Access Compliance Report

Public Rights-of-Way

(Pedestrian Signals)

Intersection ID: N/A	Main Street:	Cross Street: N/A	Location: N/A
ADA ID: 43562972E42D	Signal Type: One Push Button-APS	Overall Compliance: No	Severity Score: BTN 1: N/A BTN 2: N/A No BTN: N/A
Codes/Mitigation Info/Possible Solution		Field Measurements/Component Compliance

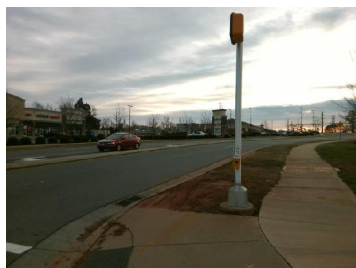
PROW/ADA: TMUTCD 4e.08, R404.2, R404.3, R404.7.2, R209.1, MUTCD 4e.10

N/A	B 1 Clear Xing Direction?	Yes	N/A	B 2 Clear Xing Direction?	N/A
	B 1 Crossing Direction	To N		B 2 Crossing Direction	N/A
No	B 1 DistanceTo XWalk (in)	72.0	N/A	B 2 DistanceTo XWalk (in)	N/A
Yes	B 1 DistanceTo Curb (in)	69.0	N/A	B 2 DistanceTo Curb (in)	N/A
Yes	B 1 Diameter (in)	2.0	N/A	B 2 Diameter (in)	N/A

Possible Solutions: Replace Signal Push Button With APS Button on New Post. Remove & Relocate Sign.
